CITY OF BEACON
One Municipal Plaza - Courtroom
BEACON, NEW YORK 12508
Phone (845) 838-5002 Fax (845) 838-5026

The Zoning Board of Appeals will meet on **Tuesday, August 20, 2019** in the Municipal Center Courtroom. A training work session will take place at 7:00 p.m. and the regular meeting will begin immediately thereafter, but not later than at 7:30 PM.

1. 1. Continue review of application submitted by 23-28 Creek Drive, LLC, 23-28 Creek Drive, Tax Grid No. 30-6054-37-037625-00, Fishkill Creek Development (FCD) Zoning District, to construct a mixed use development with eight apartments and 20,000 sq. ft. of commercial space which requires relief from the following:

Re: Application for Area Variances – Mixed-Use Development – Supplemental Submission
Premises: 23-28 Creek Drive, Beacon, New York (Tax ID: 6054-37-037625)

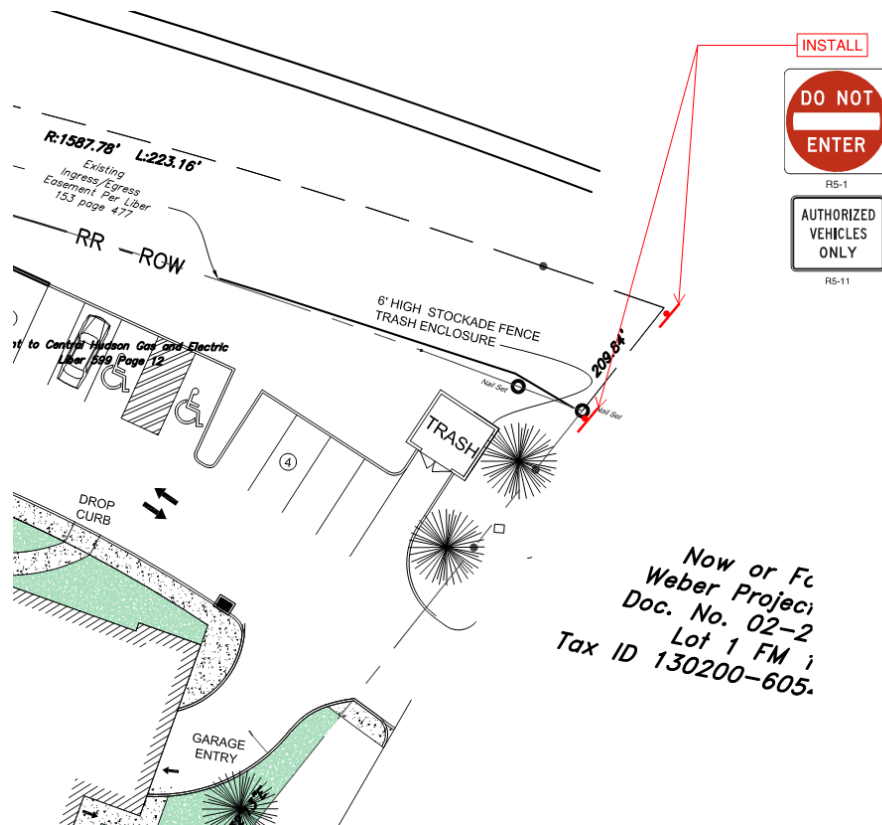
1. CM recommends that the applicant consider adding crosswalks and ramps at the internal intersection between 7-11 Creek Drive and 23-28 Creek Drive to enhance pedestrian connectivity between buildings, as shown below:

Response: Comment noted. A crosswalk and sidewalk curb ramps will be added on the west side of the intersection. A crosswalk on the east side would lead to the proposed trash enclosure for 23-28 Creek Drive and therefore does not seem to be an appropriate location for a crosswalk. See exhibits in Item No. 2 below for proposed location of this crosswalk.

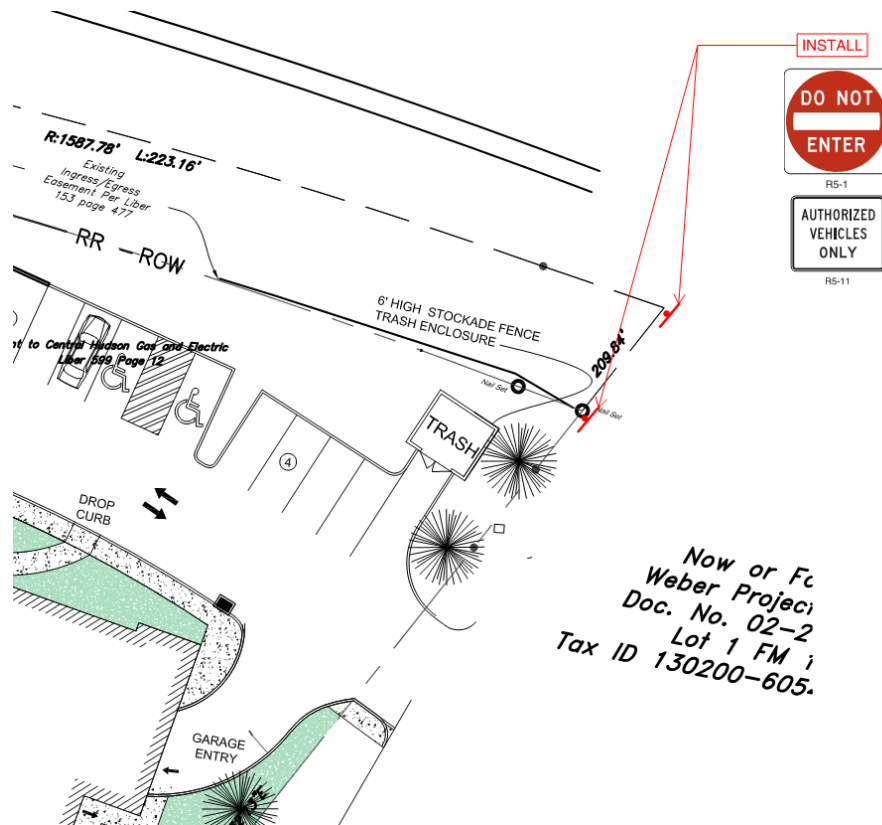
1. CM recommends that the applicant consider adding crosswalks and ramps at the internal intersection between 7-11 Creek Drive and 23-28 Creek Drive to enhance pedestrian connectivity between buildings, as shown below:

Response: Comment noted. A crosswalk and sidewalk curb ramps will be added on the west side of the intersection. A crosswalk on the east side would lead to the proposed trash enclosure for 23-28 Creek Drive and therefore does not seem to be an appropriate location for a crosswalk. See exhibits in Item No. 2 below for proposed location of this crosswalk.
